Access Compliance Report

Public Rights-of-Way

(Curb Ramps)

Intersection ID: 53746	Main Street: SPRINGWOOD_ESTATE_DR	Cross Street: CANTERBURY_CASTLE_DR	Location: SE
ADA ID: B63BD3FBE7B6	Ramp Type: Perp	Initial Pass/Fail: Fail	Overall Compliance: No
Codes/Mitigation Info/Possible Solution		Field Measurements/Component Compliance	
Severity Score: 33.75

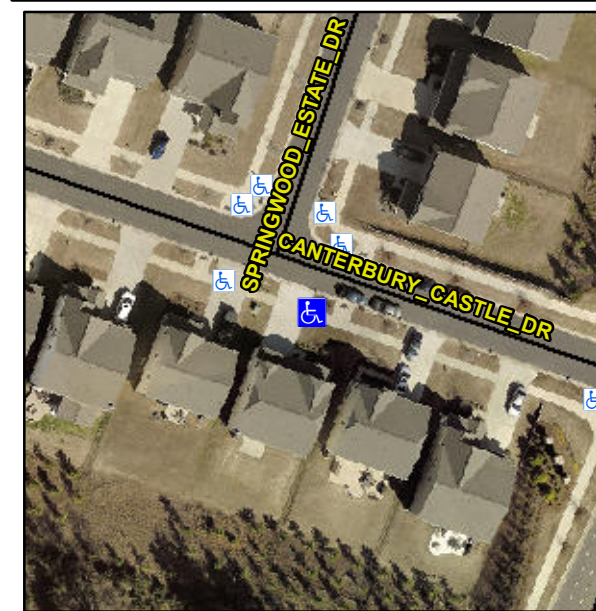
R304.5.1, R304.2.2, R304.5.3

Compliance	Description	Data	Compliance	Description	Data
N/A	Ramp Length (in)	96.0	No	Ramp Slope (%)	9.4
No	Ramp Width (in)	47.0	No	Ramp XSlope (%)	5.6
N/A	Flare Type LT	N/A	N/A	Flare Type RT	N/A
N/A	Flare Slope LT (%)	N/A	N/A	Flare Slope RT (%)	N/A
N/A	Flare Traversable LT?	N/A	N/A	Flare Traversable RT?	N/A
N/A	Landing Length (in)	N/A	N/A	DWS Provided?	N/A
N/A	Landing Width (in)	N/A	N/A	DWS Contrast?	N/A
N/A	Landing Slope (%)	N/A	N/A	DWS Length (in)	N/A
N/A	Landing X Slope (%)	N/A	N/A	DWS Full Width?	N/A
N/A	Landing Curb? (Y/N)	N/A	N/A	DWS Offset (in)	N/A
N/A	Shared Landing?	N/A			
N/A	Gutter Ponding?	N/A	N/A	Gutter Slope (%)	N/A
N/A	Gutter Lip Ht (in)	N/A	N/A	Gutter X Slope (%)	N/A
N/A	Painted X Walk1?	No	N/A	Painted X Walk2?	N/A
	X Walk 1 Direction	To NE		X Walk 2 Direction	N/A
N/A	X Walk 1 Width (in)	N/A	N/A	X Walk 2 Width (in)	N/A
	X Walk 1 Slope (%)	2.8		X Walk 2 Slope (%)	N/A
	X Walk 1 X Slope (%)	4.2		X Walk 2 X Slope (%)	N/A

Remove & Replace Entire Ramp.
